Subject: DRIVERS SIDE SEATBACK RECLINING POSITION CHANGES BY ITSELF WHEN CUSTOMER EXITS THE VEHICLE	Bulletin No: 09-020/13
	Last Issued: 09/05/2013

- This bulletin supersedes the previous bulletin 09-020/13, issued on 07/11/13. The APPLICABLE MODEL(S)/VINS, DESCRIPTION, REPAIR PROCEDURE and PART(S) INFORMATION have been revised.
- Changes are noted below in Red beside the change bar.

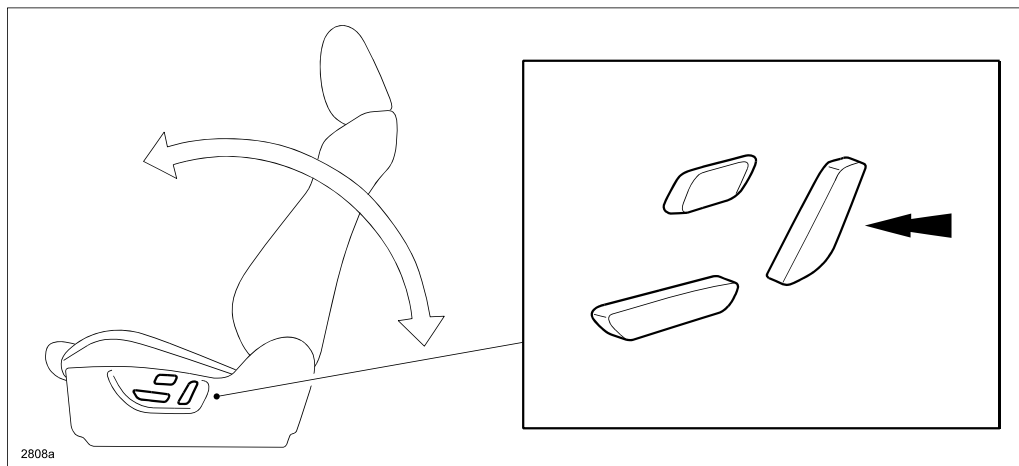
- The configuration of the recliner switch knob has been changed to eliminate this concern. Customers having this concern should have their vehicle repaired using the following repair procedure.

1. Verify the customer concern.
2. Replace the recliner switch **knob** with a modified new part according to the instructions on MS3 online or the Workshop Manual (section 09-13 FRONT SEAT SIDE COVER REMOVAL/INSTALLATION).
3. Verify the repair.

Part Number	Description	Qty.	Notes
KD35-88-1H5 -02	Recliner Switch Knob (LH)	1	Replace recliner switch knob only. Do not replace recliner switch.
